## PUBLIC HEARING MEMORANDUM

SUBJECT: **Petition #213-21** for SPECIAL PERMIT/SITE PLAN APPROVAL to raze the structure and construct a new two-family dwelling in a new configuration with four surface parking stalls at **2163 Commonwealth Avenue**, Ward 4, Auburndale, on land known as Section 41 Block 18 Lot 0032 containing approximately 10,535 sq. ft. of land in a district zoned SINGLE RESIDENCE 2. Ref: Sec. 7.3, 7.4, 7.8.2.c.2, 3.4.1 of the City of Newton Rev Zoning Ord, 2017.

**ZONING REVIEW MEMORANDUM**

MEMORANDUM

**Proposed site plan**

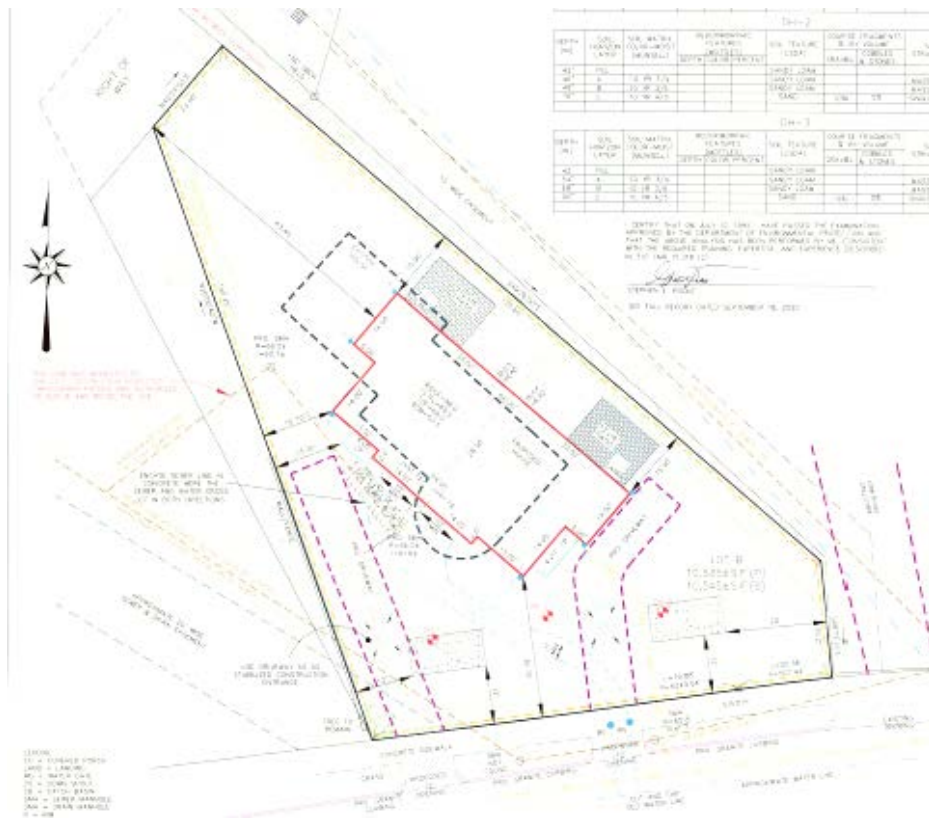
Regarding setbacks, the new dwelling would be constructed closer to the front property line along Commonwealth Avenue than the previous structure, resulting in a front setback of 30.7 feet, slightly more than the minimum 30 feet required. The two side setbacks would measure approximately 16 feet, more than the previous 13 feet (for both) and the 10 feet minimum required. At 63.4 feet the proposed rear setback would be considerably exceed the previous structure's 47 feet as well as the 15 feet required.

Each of the units would have a 12 foot by 16 foot paved patio located in the right (northeast) portion of the property.

The petitioners are proposing to provide four surface parking stalls accessed by two driveways, one for each of the two units. Each of the two driveways would have an associated 12-foot-wide curb cut; the widths of the driveways themselves are not specifically indicated and should be clarified by the petitioner. Use of the existing driveway near the right side of the property would presumably be abandoned.

The Planning Department suggests that the petitioner consider redesigning the proposed driveways to require a single curb cut, with perhaps the driveway branching off within the property to access parking areas on either side of the proposed structure. Depending on the configuration, this could serve to reduce the number of curb cuts as well as the amount of paving on the property. Also, this could allow for the avoidance of placing the left proposed driveway within the City sewer easement that crosses the property at its front left corner.

The petition has submitted a plan indicating that an existing tree at the left front (southwest) corner of the lot would be preserved. The Planning Department notes that this location could likely be affected by the new driveway that is proposed on the left side of the property and encourages the petitioner to take steps necessary to best ensure the survival of that tree.

The Planning Department suggests that the petitioner clarify the proposed retention, replacement, etc., of any fencing and/or other screening along the property's right (east, northeast) boundary lines.
